## **Agenda**

Discussion of Tentative Order No. R9-2013-0001

April 18, 2013

**DRAFT for Discussion Purposes Only**  
*Comparison of Alternative Biofiltration Sizing Standards*

Support for Percent Capture Calculations - Nomographs from TGD

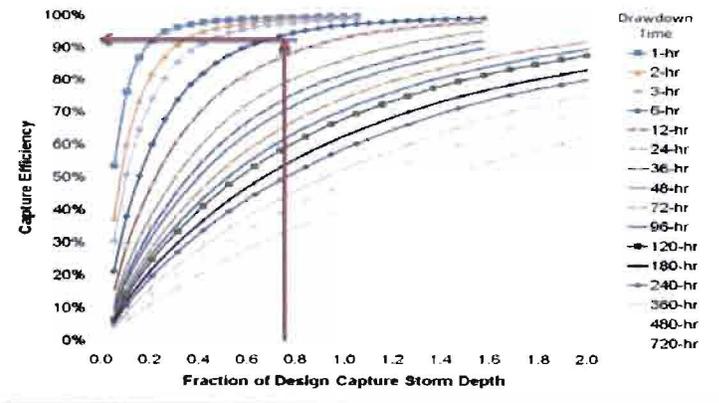
Scenario 1 - Typical Biofiltration - Median Routing Time; Typical Media Filtration Rate

Results - Biofiltration Alternative 1 - Treat 150% of the remaining DCV.	Value	Explanation
Required Biofiltration Treated Volume, cu-ft	3124	$1.5 \times$ remaining DCV
Biofiltration Footprint Required, cu-ft	1056	Req'd Biofiltration Volume / Total Depth Treated + Stored
Storage Volume as fraction of remaining DCV	0.76	Storage volume / Remaining DCV
Average Annual Capture Efficiency	92%	From TGD nomograph; see below

Results - Biofiltration Alternative 2 - Store 0.75 of remaining DCV in pores and ponding.	Value	Explanation
Required Biofiltration Storage Volume, surface + pores	1562	$0.75 \times$ remaining DCV
Footprint Area, sq-ft	1041	required biofiltration storage volume / total storage depth (ponding + pores)
Effective storm volume filtered and stored during routing period, cu-ft	3081	Total stored plus filtered depth; multiplied by footprint area
Storage Volume as fraction of remaining DCV	0.75	
Average Annual Capture Efficiency	92%	From TGD nomograph; see below

Summary Comparison	Biofiltration Sizing Alternatives	
	Alt 1 - 150% treat	Alt 2 - 0.75 storage
Footprint	1,056	1,041
Effective Storm Volume Treated	3,124	3,081
Average Annual Capture Efficiency	92%	92%

Red = 150 percent treat; Blue = 75 percent store

Support for Percent Capture Calculations - Nomographs from TGD  
 Red = 150 percent treat; Blue = 75 percent store

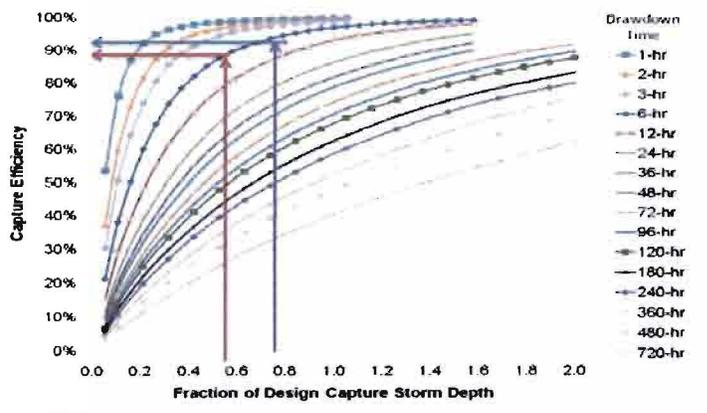
Comparison of Alternative Biofiltration Sizing Standards  
 Scenario 2 - Typical Biofiltration - Longer Routing Time

Results - Biofiltration Alternative 1 - Treat 150% of the remaining DCV.	Value	Explanation
Required Biofiltration Treated Volume, cu-ft	3124	$1.5 \times$ remaining DCV
Biofiltration Footprint Required, cu-ft	781	Req'd Biofiltration Volume / Total Depth Treated + Stored
Storage Volume as fraction of remaining DCV	0.56	Storage volume / Remaining DCV
Average Annual Capture Efficiency	87%	From TGD nomograph; see below

Results - Biofiltration Alternative 2 - Store 0.75 of remaining DCV in pores and ponding.	Value	Explanation
Required Biofiltration Storage Volume, surface + pores	1562	$0.75 \times$ remaining DCV
Footprint Area, sq-ft	1041	required biofiltration storage volume / total storage depth (ponding + pores)
Effective storm volume filtered and stored during routing period, cu-ft	4165	Total stored plus filtered depth; multiplied by footprint area
Storage Volume as fraction of remaining DCV	0.75	
Average Annual Capture Efficiency	92%	From TGD nomograph; see below

Summary Comparison	Biofiltration Sizing Alternatives	
	Alt 1 - 150% treat	Alt 2 - 0.75 storage
Footprint	781	1,041
Effective Storm Volume Treated	3,124	4,165
Average Annual Capture Efficiency	87%	92%

**Support for Percent Capture Calculations - Nomographs from TGD**

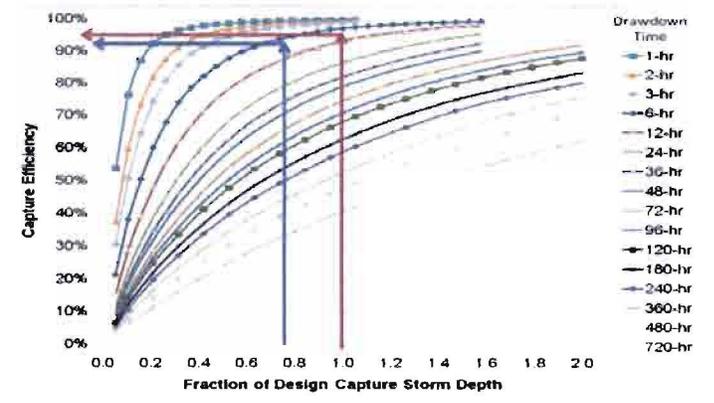
**Comparison of Alternative Biofiltration Sizing Standards  
Scenario 3 - Typical Biofiltration - Shorter Routing Time**

Results - Biofiltration Alternative 1 - Treat 150% of the remaining DCV.		
	Value	Explanation
Required Biofiltration Treated Volume, cu-ft	3124	$1.5 \times \text{remaining DCV}$
Biofiltration Footprint Required, cu-ft	1339	Req'd Biofiltration Volume / Total Depth Treated + Stored
Storage Volume as fraction of remaining DCV	0.96	Storage volume / Remaining DCV
Average Annual Capture Efficiency	95%	From TGD nomograph; see below

Results - Biofiltration Alternative 2 - Store 0.75 of remaining DCV in pores and ponding.		
	Value	Explanation
Required Biofiltration Storage Volume, surface + pores	1562	$0.75 \times \text{remaining DCV}$
Footprint Area, sq-ft	1041	required biofiltration storage volume / total storage depth (ponding + pores)
Effective storm volume: filtered and stored during routing period, cu-ft	2430	Total stored plus filtered depth; multiplied by footprint area
Storage Volume as fraction of remaining DCV	0.75	
Average Annual Capture Efficiency	92%	From TGD nomograph; see below

Summary Comparison	Biofiltration Sizing Alternatives	
	Alt 1 - 150% treat	Alt 2 - 0.75 storage
Footprint	1,339	1,041
Effective Storm Volume Treated	3,124	2,430
Average Annual Capture Efficiency	95%	92%

Red = 150 percent treat; Blue = 75 percent store

Support for Percent Capture Calculations - Nomographs from TGD

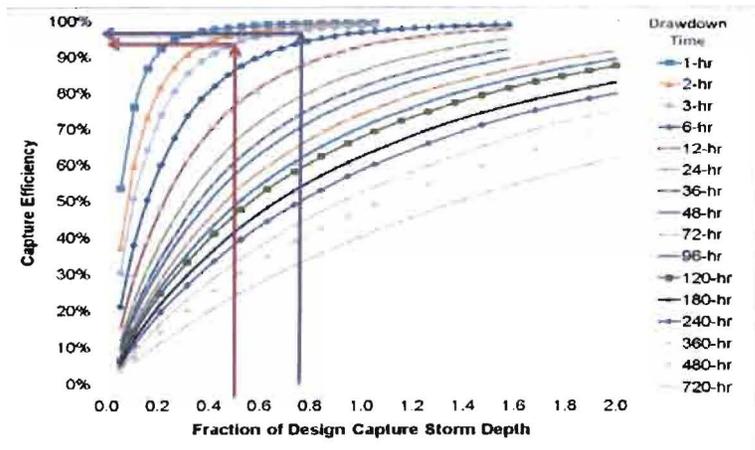
Comparison of Alternative Biofiltration Sizing Standards  
 Scenario 4 - Typical Biofiltration - Higher Media Flowrate

Results - Biofiltration Alternative 1 - Treat 150% of the remaining DCV.	Value	Explanation
Required Biofiltration Treated Volume, cu-ft	3124	$1.5 \times$ remaining DCV
Biofiltration Footprint Required, cu-ft	707	Req'd Biofiltration Volume / Total Depth Treated + Stored
Storage Volume as fraction of remaining DCV	0.51	Storage volume / Remaining DCV
Average Annual Capture Efficiency	93%	From TGD nomograph; see below

Results - Biofiltration Alternative 2 - Store 0.75 of remaining DCV in pores and ponding.	Value	Explanation
Required Biofiltration Storage Volume, surface + pores	1562	$0.75 \times$ remaining DCV
Footprint Area, sq-ft	1041	required biofiltration storage volume / total storage depth (ponding + pores)
Effective storm volume filtered and stored during routing period, cu-ft	4599	Total stored plus filtered depth; multiplied by footprint area
Storage Volume as fraction of remaining DCV	0.75	
Average Annual Capture Efficiency	96%	From TGD nomograph; see below

Summary Comparison	Biofiltration Sizing Alternatives	
	Alt 1 - 150% treat	Alt 2 - 0.75 storage
Footprint	707	1,041
Effective Storm Volume Treated	3,124	4,599
Average Annual Capture Efficiency	93%	96%

Red = 150 percent treat; Blue = 75 percent store
